| <b>DOCKETED</b>         |   |
|-------------------------|---|
| <b>Project Title:</b>   | Soda Mountain Solar   |
| <b>Document Title:</b>  | Onsite Water Supply - Reference Document 3                      |

# Hydrogeologic Conditions and Groundwater Modeling Report Addendum

Soda Mountain Solar Project  
BLM Case No. CACA 49584

Figure 1: Project Location

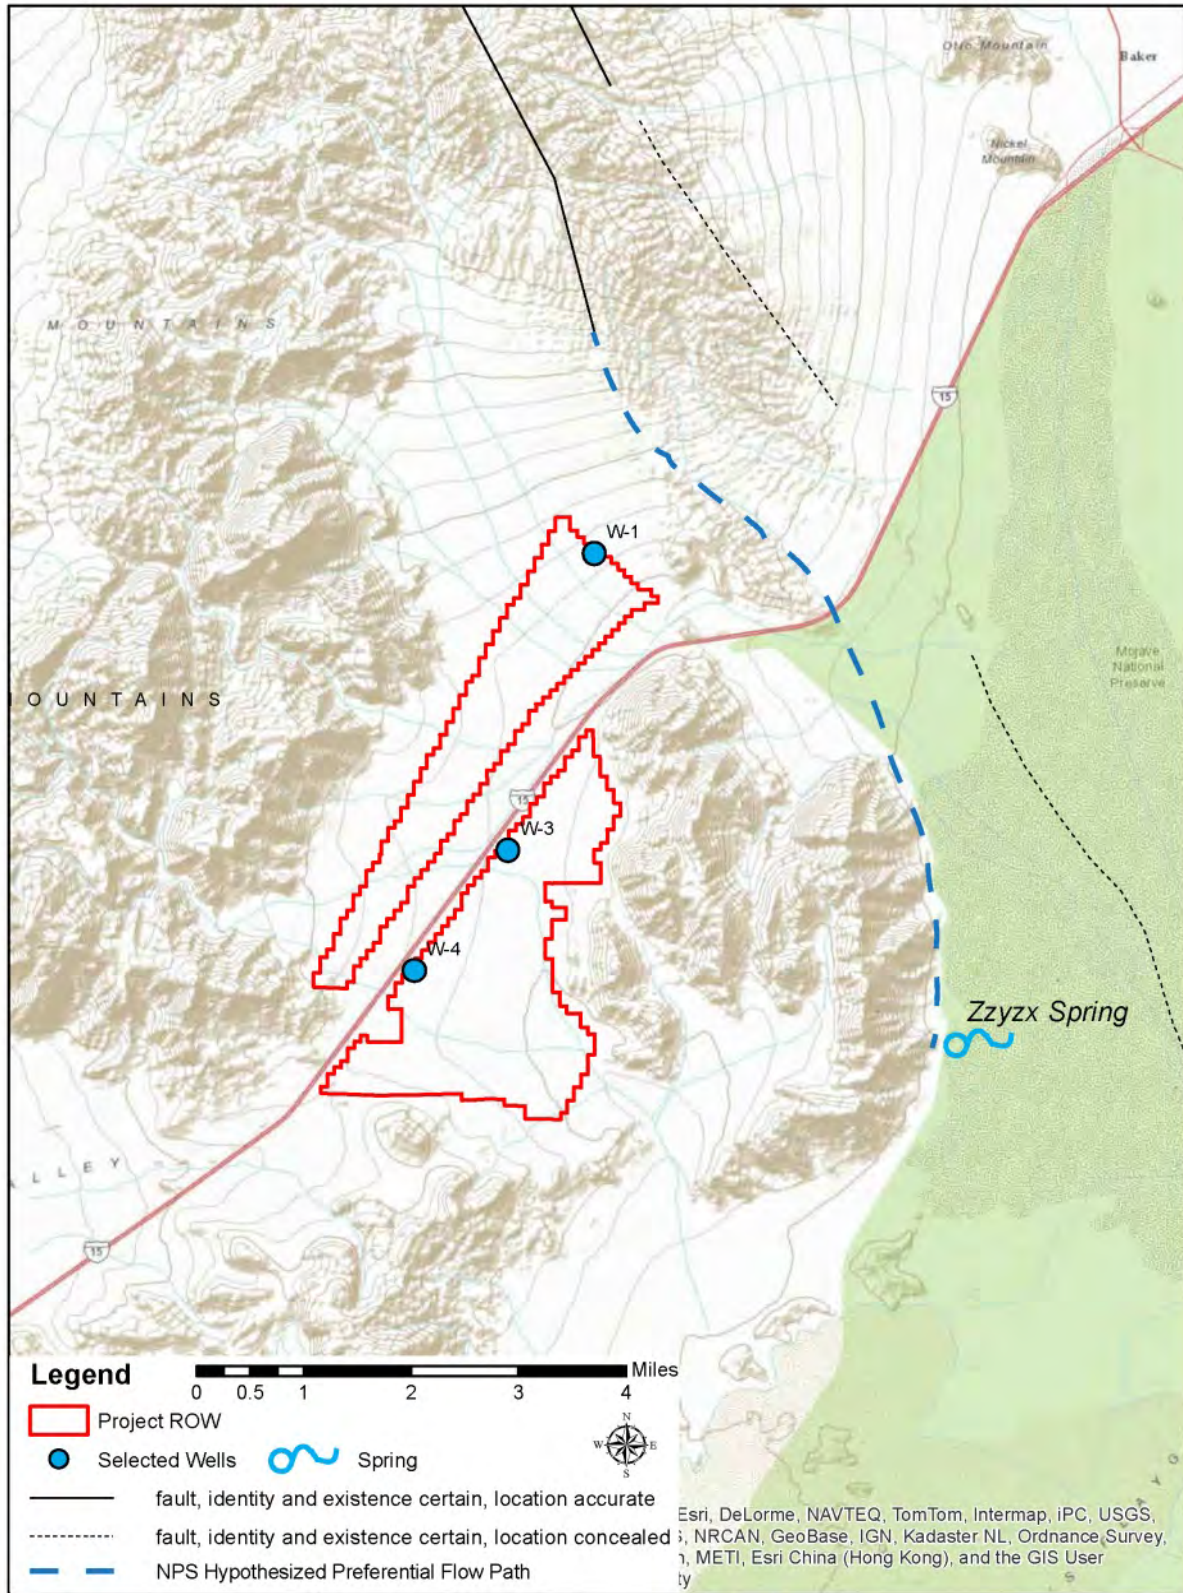
NPS commented that the model did not adequately address potential impacts to Soda Springs at Zzyzx, habitat for the Mohave tui chub (*Siphateles bicolor ssp. Mohavensis*).

The U.S. Fish and Wildlife Service (USFWS) listed the tui chub as endangered in 1970. California Department of Fish and Wildlife (CDFW) lists the species as endangered and a fully protected species. The revised modeling presented in this addendum evaluated groundwater drawdown at two locations to assess potential impacts on Soda Springs at Zzyzx and associated tui chub habitat:

1. NPS's hypothesized preferential flow path (Figure 1)
2. The western edge of the Soda Mountains

It is highly unlikely that the volcanic bedrock forming the Soda Mountains and sidewalls of the Soda Mountain Valley are permeable enough to allow for a significant outflow of groundwater from the valley. Groundwater levels in the valley are approximately 1232 feet amsl at TEM-02, and 1170 feet amsl at TEM-09, and thus are over 200 feet higher than groundwater levels near Soda Springs (Barthel 2008; Vargas 2012). If there were substantial discharge through the bedrock, elevated groundwater levels could not be maintained in the valley over 200 feet higher than the water level near Soda Springs adjacent to the Soda Lake playa; the Soda Mountain Valley groundwater basin would drain.

Groundwater modeling results presented here indicate that drawdown of water levels near the edge of the valley adjacent to the west flank of the south Soda Mountains would generally be less than 2 feet at any time during construction or operation. The small drawdown at the edge of the valley would attenuate to negligible levels over the 3 miles of bedrock separating the valley from the Soda Springs area at Zzyzx. In comparison, groundwater levels in monitoring wells near Zzyzx fluctuate naturally by 1 to 2 feet with no effect on the level of Soda Springs (Barthel 2008).

Figure 3: Geologic Cross Sections

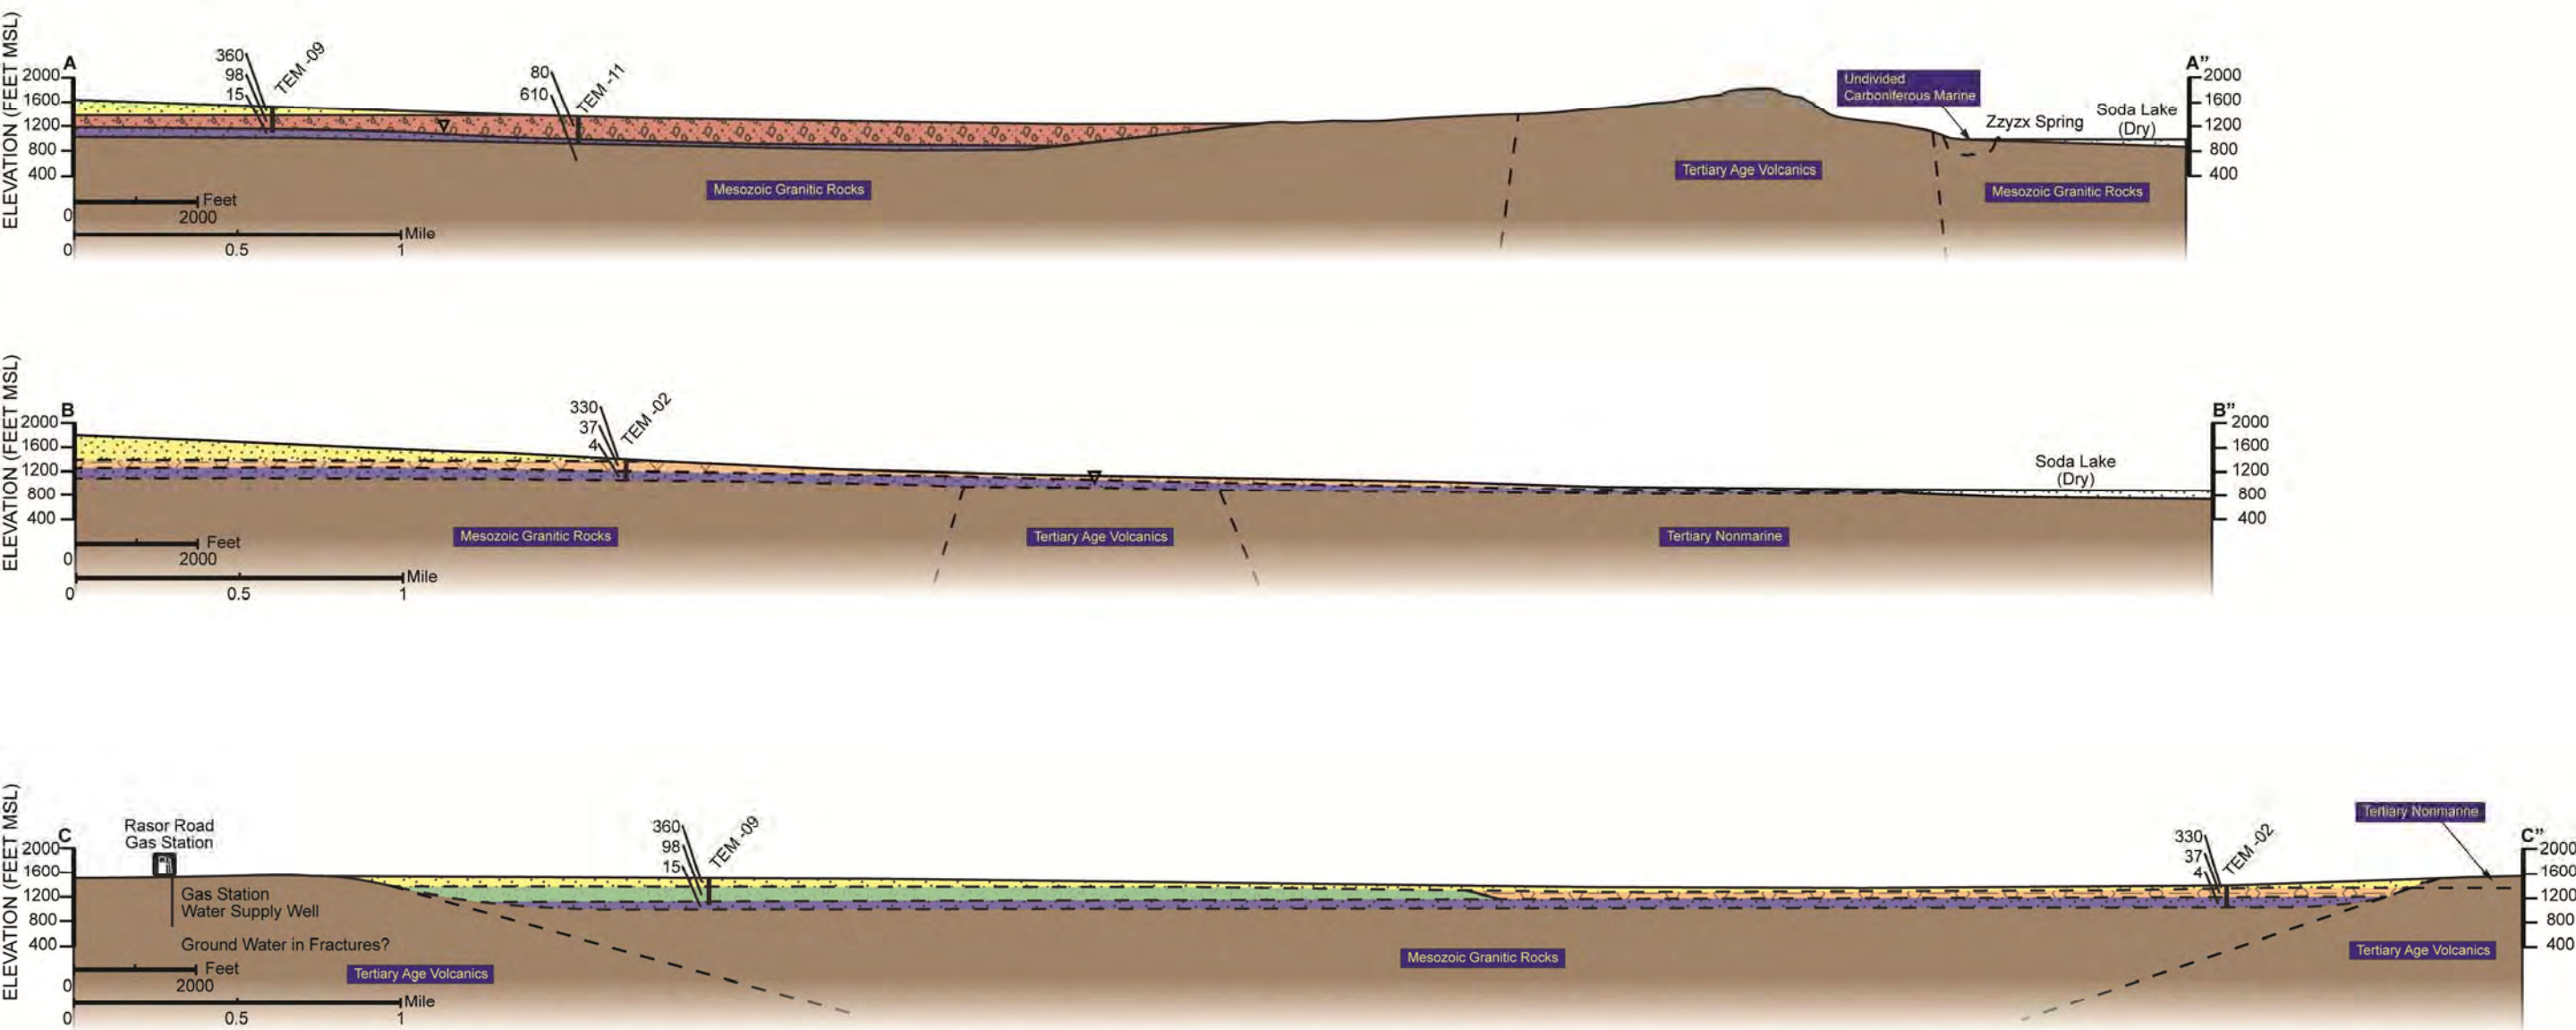
- The modeling assumed an overly high recharge rate.
- The model did not account for the possibility of permeable bedrock to the east of the project area. NPS suggested one potential source from which Soda Springs at Zzyzx might derive significant flow is a potential preferential groundwater flow path extending from known fracture traces north and south of the Soda Springs at Zzyzx. The NPS’s hypothesized preferential flow path is illustrated in Figure 1.
- The analysis did not adequately addresses potential impacts to the springs at Zzyzx.

NPS commented that the model incorrectly assumed impermeable boundaries that precluded flow to the east beyond the Soda Mountains.

A cross section location map is presented in Figure 2. Revised cross sections A–A', B–B', and C–C' are presented in Figure 3. These cross sections were previously presented in RMT's 2011 Model Report. The revised cross sections do not display the vertical exaggeration used in the Model Report (which caused potential confusion over the distance between the springs at Zzyzx and the proposed groundwater wells). The revised cross sections also include the type and extent of bedrock units. The following discussion is derived largely from the Model Report, with additional discussion of the bedrock geology.

Cross section A–A' extends west to east and incorporates geophysical data from TEM-09 and TEM-11, which are located near the southern end of the valley (Figure 3). The cross section extends eastward across the mountain range to Soda Springs at Zzyzx, located on the eastern slope of the eastern Soda Mountains, above Soda Lake. Bedrock occurs at depths of 500 feet or more below ground surface (bgs) at TEM-09 and 436 feet bgs at TEM-11. The bedrock outcrops on the slopes of the Soda Mountains. Geologic mapping from Jenkins (1962) and Wilson (2011) indicates that Mesozoic granitic rocks make up much of the subsurface bedrock, with Jurassic-Triassic metavolcanic rocks forming significant portions and higher reaches of the Soda Mountains. A localized outcrop of carbonate rock is present in the vicinity of Soda Springs at Zzyzx, but its mapped extent appears to be limited to the vicinity of the spring (Jenkins 1962).

The water table occurs at an elevation of approximately 1,170 feet amsl at TEM-09, and appears to be below an elevation of approximately 922 feet amsl at TEM-11. The apparently much lower water table at TEM-11 suggests that there is an outlet for groundwater southeast of TEM-11 that allows the water table to drain to this lower elevation. A surface-water outlet is present in the southeast portion of the valley (Figure 2), and it is reasonable to assume an alluvium valley fill bedrock cut exists at this location. This conceptual model satisfies the need for a groundwater outlet to occur in the southeast portion of the valley, where the water table is apparently much lower than elsewhere, as seen at TEM-11.

cross section A–A', there may be a buried bedrock valley at this location. The funneling of surface water through this narrow gap suggests that there may be coarser sediments in the valley fill at this location. A small outcrop of limestone present near Zzyzx east of Soda Mountain on cross section point A is labeled as Undivided Carboniferous Marine. Extrapolation of mapped bedrock units into the subsurface indicates that Mesozoic granitic rocks predominate in the western portion of cross section point B, and Tertiary volcanic rocks form the central portion of the cross section. Tertiary nonmarine rocks are mapped in the eastern portion of the cross section, extending to the areas beneath Soda Lake.

The water table is interpreted to be at a depth of approximately 182 feet bgs at TEM-02 (elevation of 1,232 feet amsl), the shallowest groundwater occurrence of any of the three TEM locations. The groundwater elevation at TEM-02 is approximately 300 feet higher than the water table in the Soda Lake Valley located east of the project area (Figure 2). Groundwater elevations in the Soda Lake Valley range from 945 feet amsl to 958 feet amsl based on available U.S. Geological Survey (USGS) data (USGS 2013). Soda Springs at Zzyzx is located at an elevation of 948 feet approximately 200 to 300 feet below the groundwater elevation in the Soda Mountain Valley. The conceptual model illustrated on cross section B–B' is that the water table slopes steadily eastward from the upper reaches of the alluvial fans to the base of the valley. Groundwater is channeled through the relatively narrow buried valley outlet located near the northeast corner of the project area, flowing eastward toward the Soda Lake lowlands.

Cross section C–C' extends northeast to southwest down the longitudinal axis of the valley (Figure 3). From south to north, bedrock units represented in the valley include Tertiary volcanic rocks (rhyolite, andesite), Mesozoic granitic rocks, and Jurassic-Triassic metavolcanic rocks.

The model boundaries were defined using geologic data and geophysical information. The Soda Mountain Valley is surrounded by low-permeability granitic and volcanic rock. The model covers the alluvium within the valley. The low permeability rocks define the model boundaries. The cross sections in the Model Report have been updated with geologic information from existing published geologic maps (Figure 3). The geologic cross sections illustrate the nature and extent of bedrock that forms the mountains in the area, and verifies that carbonate rocks, which might have solution openings and be more permeable than the typical bedrock, are not pervasive in the area. The model domain reflects the geologic conditions in the area by assuming no flow through the granitic and volcanic rock to the east and flow through an outlet to the east and an outlet to the south where alluvium is present.

Observed conditions at the site and in the regional groundwater system support the presence of low permeability through fractured bedrock in the Soda Mountain. The water table in the valley is situated approximately 200 to 300 feet above the surface of Soda Lake and substantial fracturing and groundwater discharge through the mountains would have drained the Soda Mountain Valley groundwater basin. As discussed previously, geophysical evidence shows the presence of several hundred feet of saturated alluvium in the valley (Terra Physics 2010).

The existing model incorporated focused discharge through two outlets from the valley, the northeast and the southeast outlets, that allowed groundwater to flow from the model domain to the east. The model simulated groundwater discharge into Soda Lake through these two outlets. The model was therefore not surrounded entirely with impermeable boundaries.
